TRANS/WP.29/GRRF/2002/7
22 November 2001

PROPOSAL FOR DRAFT AMENDMENTS TO REGULATION No. 13
(Braking)

Transmitted by the expert from Germany

Note: The text reproduced below was prepared by the expert from Germany on behalf of the informal group "modular type approval of trailers" in order to update the proposal for a modular type approval of trailers contained in documents TRANS/WP.29/GRRF/2000/20 and Addendum 1.

Annex 19 - appendix 7,

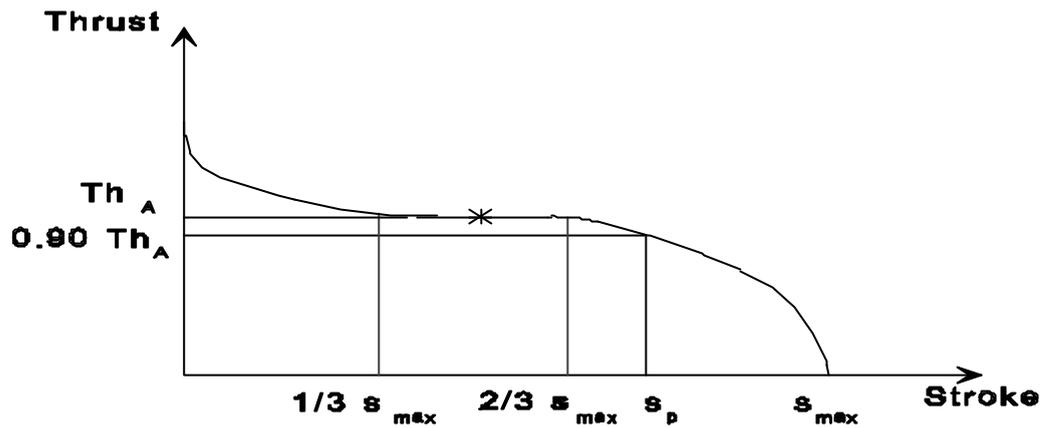
Insert, after the table, the following diagram:
